PRODUCT/PROCESS CHANGE NOTICE (PCN)

PCN #: **TB1912-02(R1)** DATE **June 9, 2020**
Product Affected: **3mm X 3mm VFQFN**
4mm X 4mm VFQFN
(Refer to attachment for affected part#)
Date Effective: **June 9, 2020**

Revision 1: This revised notice is to retract the changes as stated in the original PCN# TB1912-02 issued in December 20, 2019 after taking customers' input into consideration. With this, changes as stated in the original PCN will not be implemented.

Future Shipment in Cut Tape Packing for MSL 2/3/4 Product

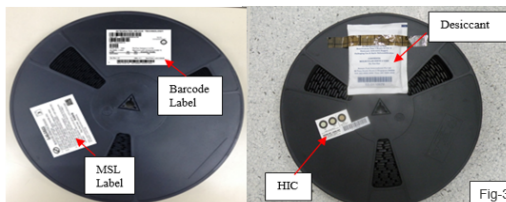
- Count and cut the parts in carrier tape as per order qty (Fig-1).
Note: Without Leader & Trailer empty pockets.
- Roll the part onto plastic reel and tape with conductive tape at both end (Fig-2 & 3).
**** Note :** Pass IDT Standard 6 fts drop test (Base on drop test result with NLG 16 (QFN 3x3 mm) and NLG 24 (QFN 4x4 mm))
- Pack with HIC & Desiccant
- Pack with MBB bag (Fig-4).
- Pack with pizza box (Fig-5&6).
- Over-pack the pizza box with Outer carton (Fig-7).
